PLAN VIEW – EXPANSION JOINT

(PIER 1 – WESTBOUND)

PROJECT — BRIDGE NO. 68 SOUTH BURLINGTON U.S. 2 OVER I-89
STATE PROJECT — IM DECK (36)
FEDERAL PROJECT —
CUSTOMER — J A McDONALD
LOCATION — CHITTENDEN COUNTY, VERMONT
DESCRIPTION — EXPANSION JOINT DETAILS WESTBOUND AT PIER 1

SHEET NO. 1 OF 8 | Job. No. : 978.1049.1

ELEVATION VIEW

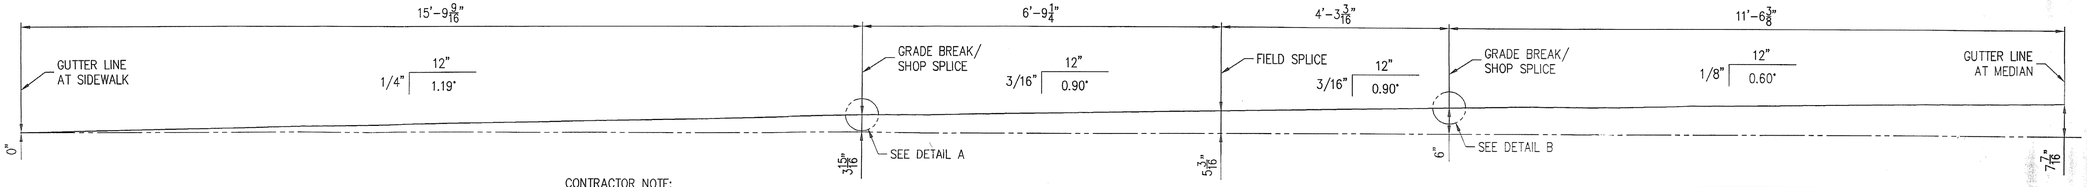
APPROVER NOTE:
STOOL LENGTHS HAVE BEEN REVISED PER CONTRACTORS FIELD MEASUREMENTS TAKEN JANUARY 19, 2001.
